**SUBJECT:** Letter of Objection in regards to Development Application No. 19 244758 NNY 16 OZ for 801 York Mills Road and 1855 Leslie Street

**Figure 1:** the proposed development site is not colored, so is considered “all other areas of the City”, not Policy Area 4 (source: [City of Toronto](#))

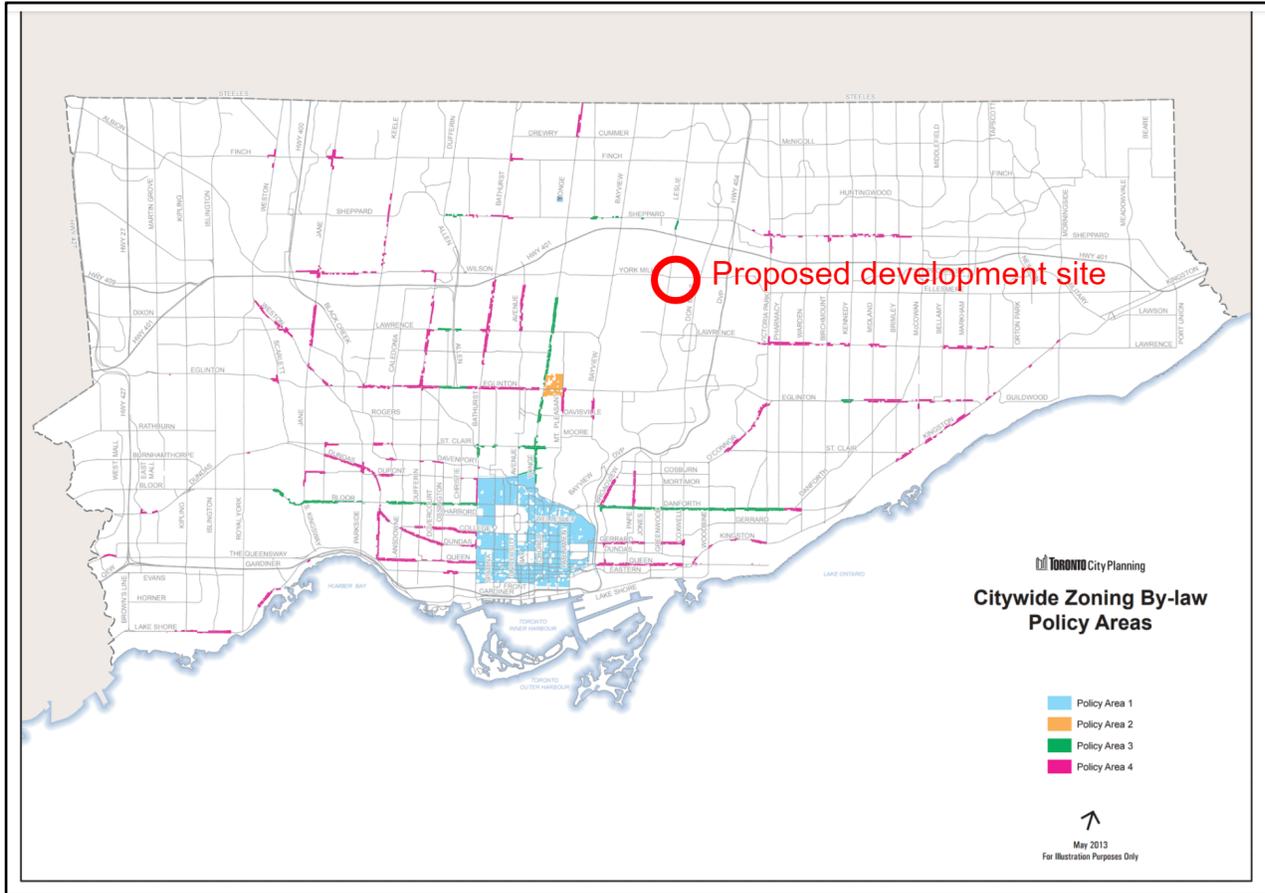
The Zoning By-law for this area is 569-2013. However, the developer quotes statistics for "Policy Area 4", which this Site does not fall into. Therefore, the calculation of traffic flow, population, parking spaces and use of public transit is erroneous (see Appendix: Figure 1). This is the most egregious error, which is the ultimate root cause of many of the proposal's subsequent mistakes.

**Figure 3:** the apartment buildings referenced by FCR’s report are all near subway stations, none of which are remotely close to the Site

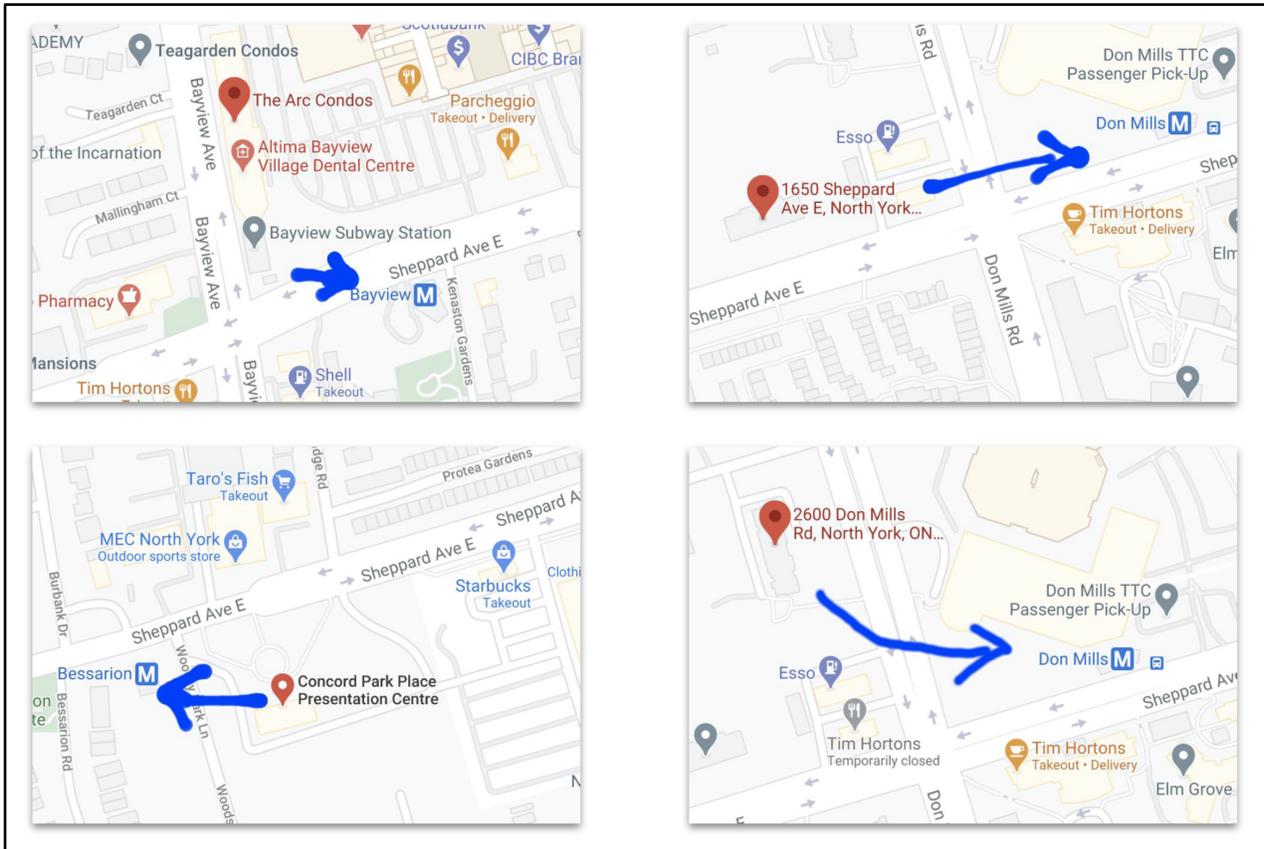
The wrong Policy Area also means the developers have misrepresented the percentage of people using public transit for work and school. The trip generation rates are related to high-rises that are within a short walking distance to subway stations. There is no subway within reasonable walking distance to York Mills and Leslie (see Appendix: Figure 3). Again, their study is faulty and has been used to serve their own interests. Furthermore, this area does not fall within areas designated for intensification according to [Toronto's Official Plan](#).
